SOUTHERN CALIFORNIA EDISON CIRCLE CITY SUBSTATION AND MIRA LOMA-JEFFERSON 66 KV SUBTRANSMISSION LINE PROJECT

Final Environmental Impact Report

December 2018

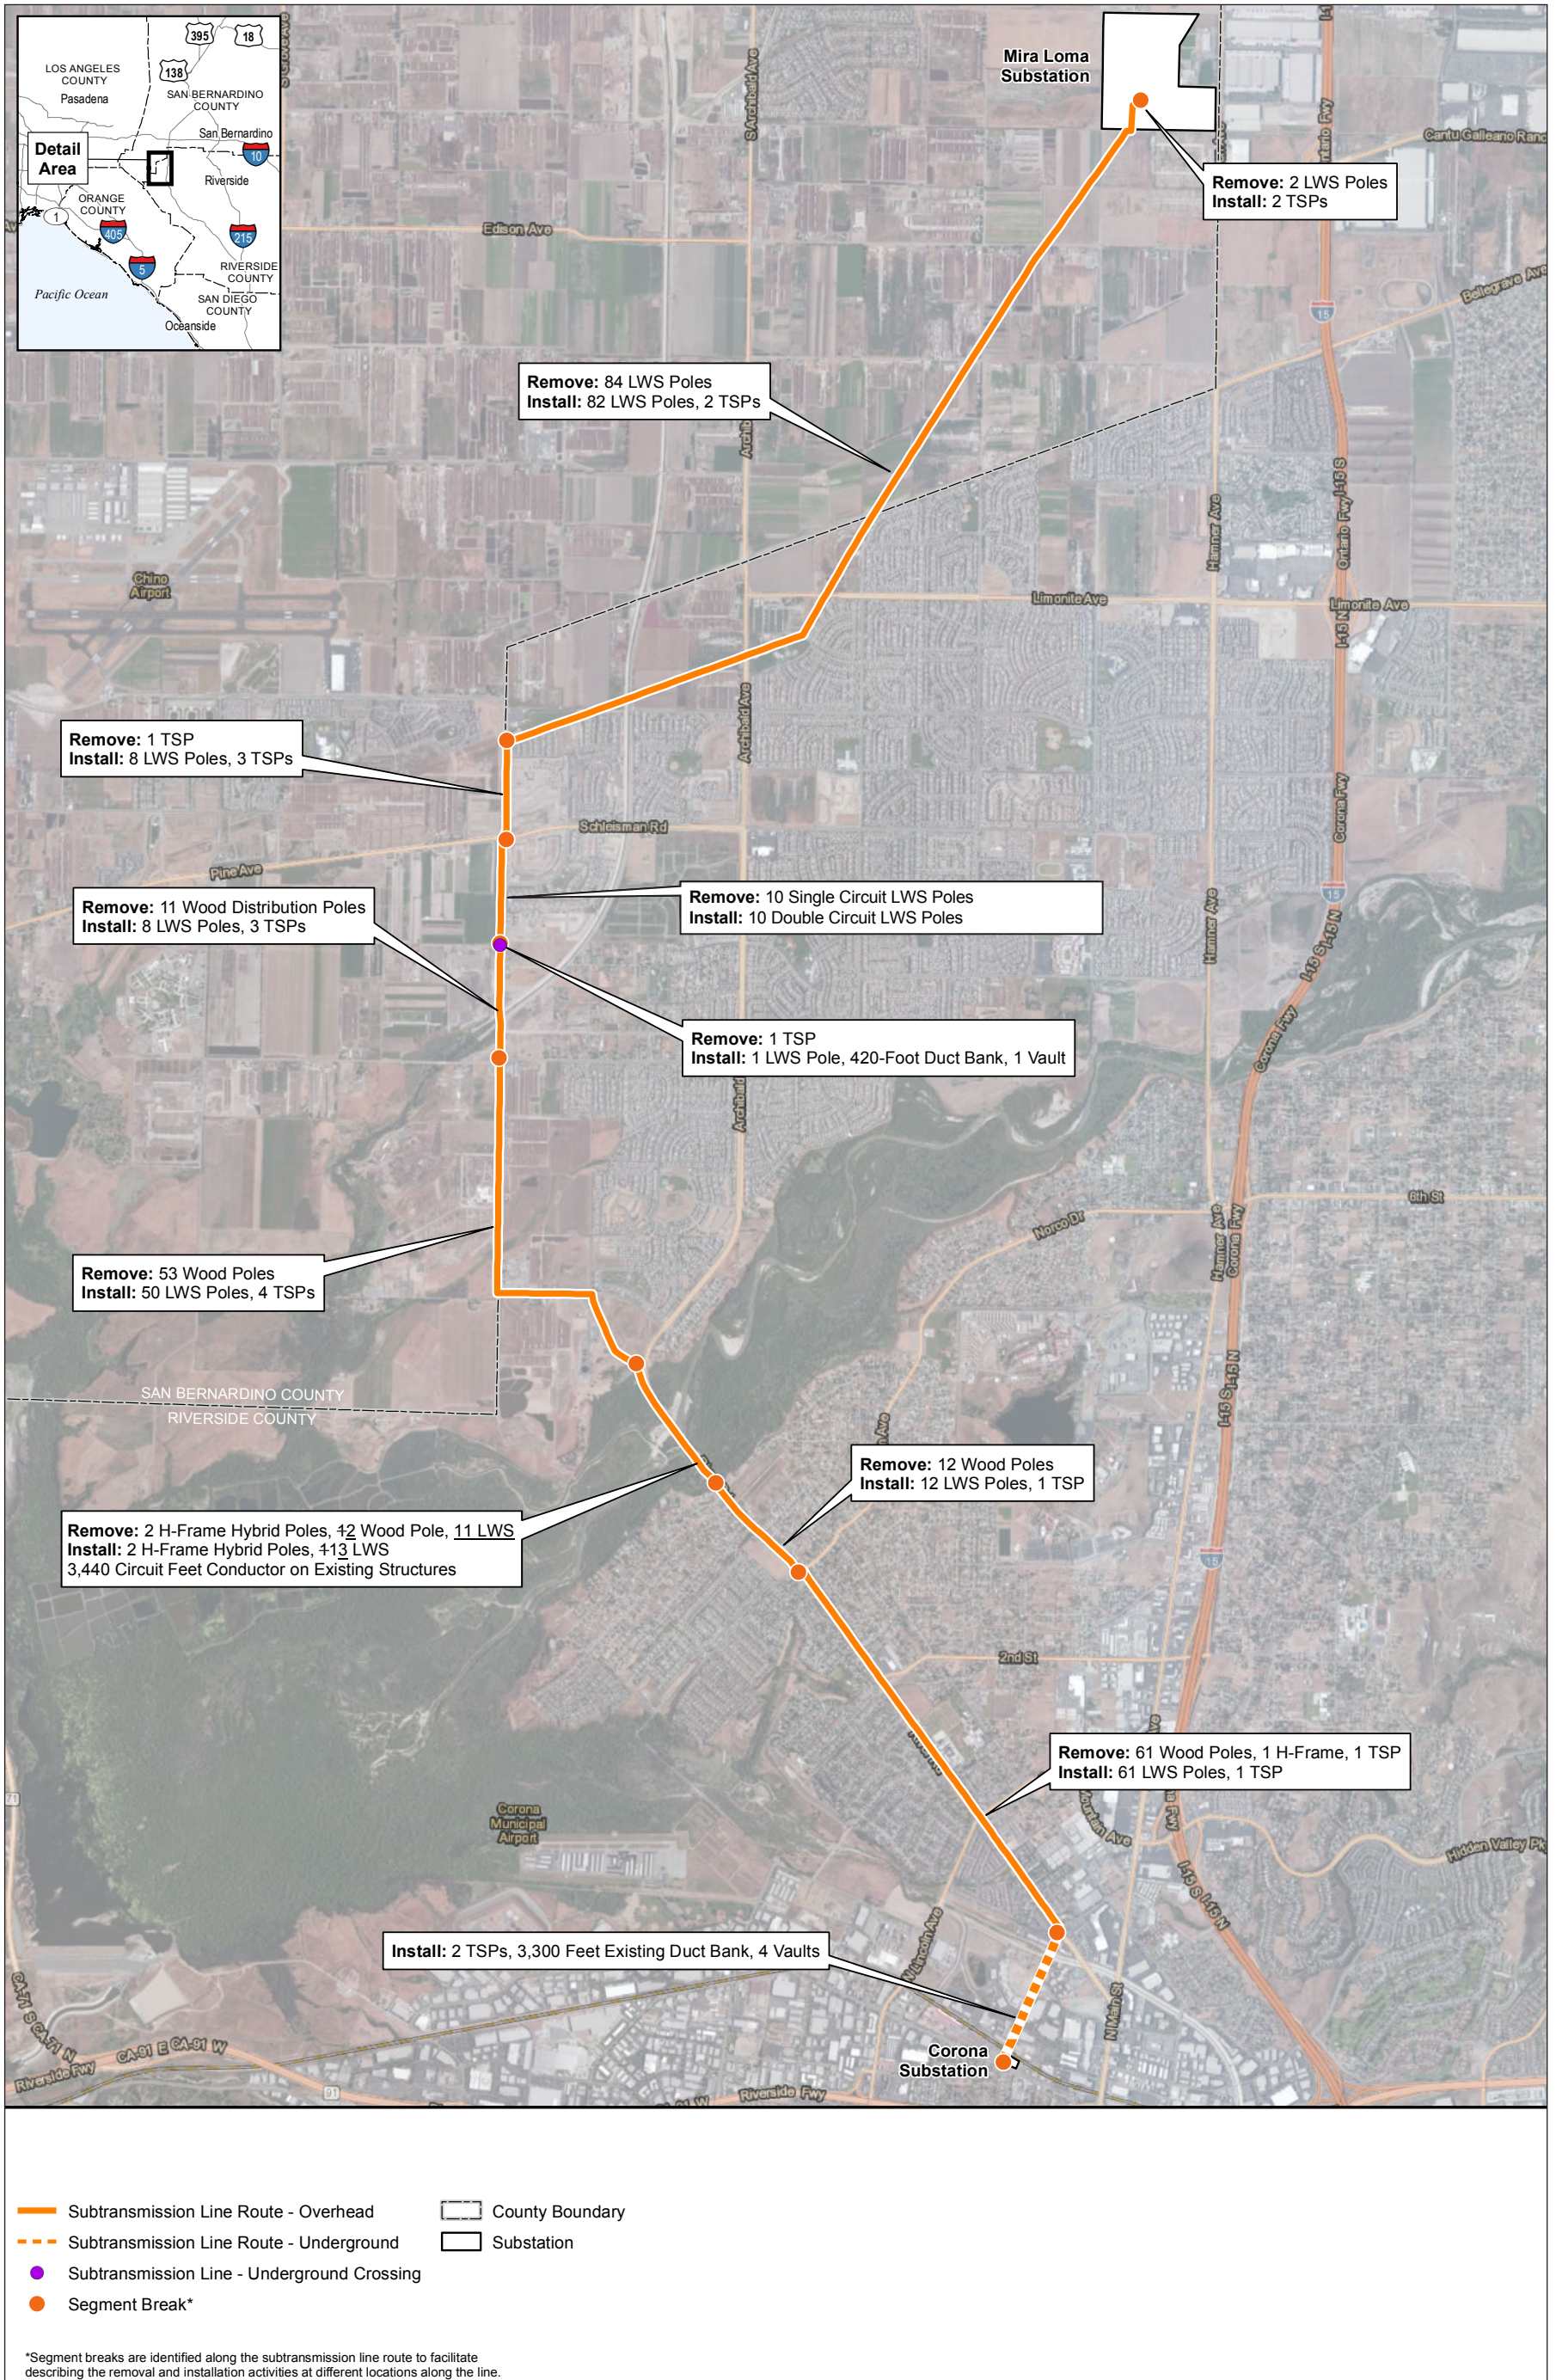
- A20-51 The proposed poles to be replaced and the poles to be installed that would be associated with the Mira Loma-Jefferson 66 kV Line in the vicinity of the Santa Ana River crossing, as discussed in the Draft EIR Section 2.5.2.4 text and as illustrated in Figure 2-17, correctly reflect the revised pole information provided by SCE in its response to CPUC Data Request No. 2, Question 2. The correct pole information was considered in the Draft EIR environmental analysis; however, the commenter correctly points out that the call-out text box in the vicinity of the Santa Ana River crossing in Draft EIR Figure 2-6 includes outdated pole information. Therefore, Draft EIR Figure 2-6 has been revised to reflect the correct amount of poles to be removed and installed in the vicinity of Santa Ana River. Refer to the revisions to *Chapter 2, Project Description*, in Final EIR Chapter 4, *Revisions to the Draft EIR*, for the updated Figure 2-6.

Draft EIR Figure 2-6 has been revised as shown on the following page to reflect the correct amount of poles to be removed and installed in the vicinity of Santa Ana River.

Figure 4.7-1
Earthquake Faults and Hazard Zones in the Project Vicinity

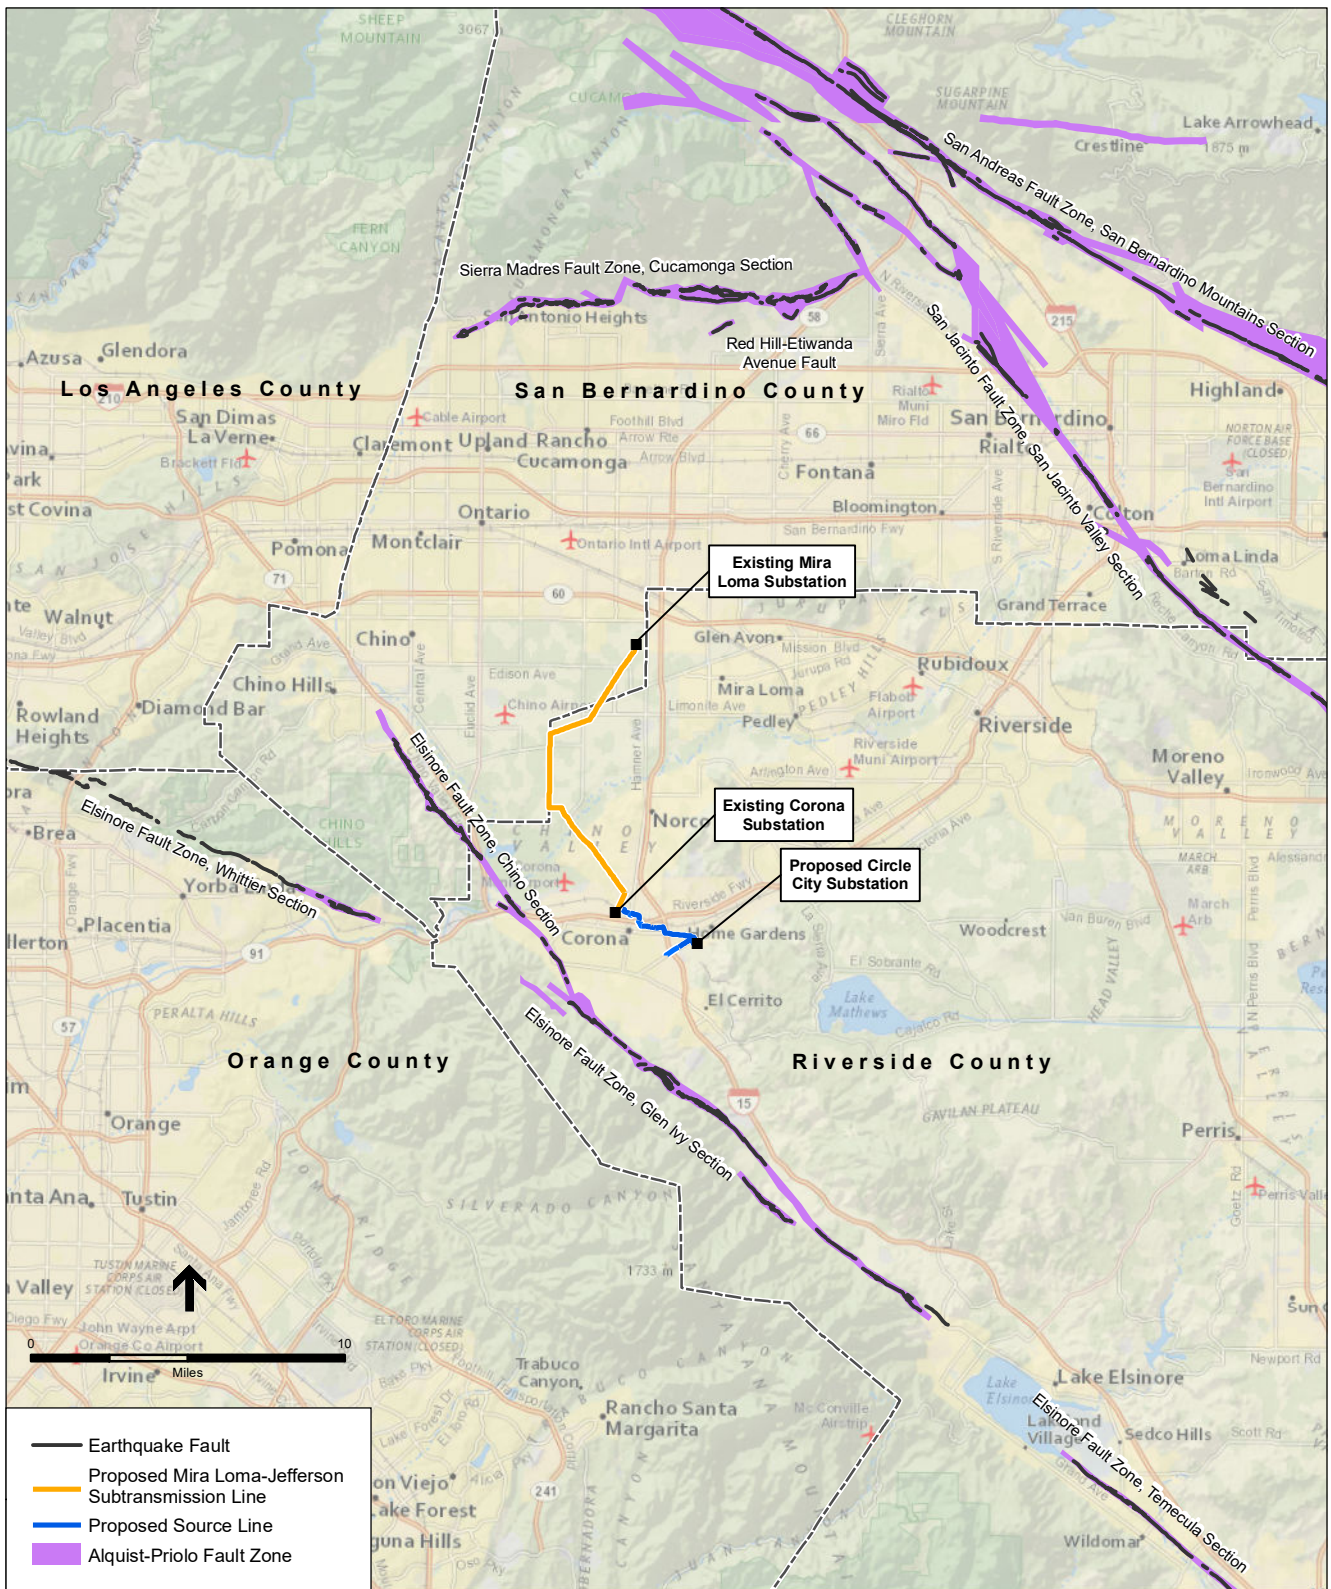
4.7.1.2	4.7-1	Under Faults, the 2 nd sentence states: "Figure 4.7-1 provides an illustration of mapped faults in the area of the proposed Project."	Please change sentence to clarify the faults shown on the figure as: "Figure 4.7-1 provides an illustration of <u>the major</u> mapped <u>earthquake</u> faults in the area of the proposed Project."	Proposed edits are intended for technical accuracy as Figure 4.7.1 only shows the major Alquist Priolo (AP) faults and associated zones, i.e., not all mapped faults are shown.

4.7.1.2	4.7-2	Figure 4.7-1 is titled "Earthquake Faults and Hazard in the Project Vicinity"	Please revise title as follows: "Earthquake Faults and Hazard <u>Zones</u> in the Project Vicinity"	Proposed edits are intended for technical accuracy and to make clear that the figure refers to the AP Earthquake Fault Zones.

A20-121 The commenter suggests additions to clarify the Draft EIR. The title of Draft EIR Figure 4.7-1 has been revised to “Earthquake Faults and Hazard Zones in the Project Vicinity” in response to this comment. The revisions to this figure do not result in any changes to the environmental analysis included in the Draft EIR.

The title of Draft EIR Figure 4.7-1 has been revised as shown on the following page to “Earthquake Faults and Hazard Zones in the Project Vicinity” in response to this comment.
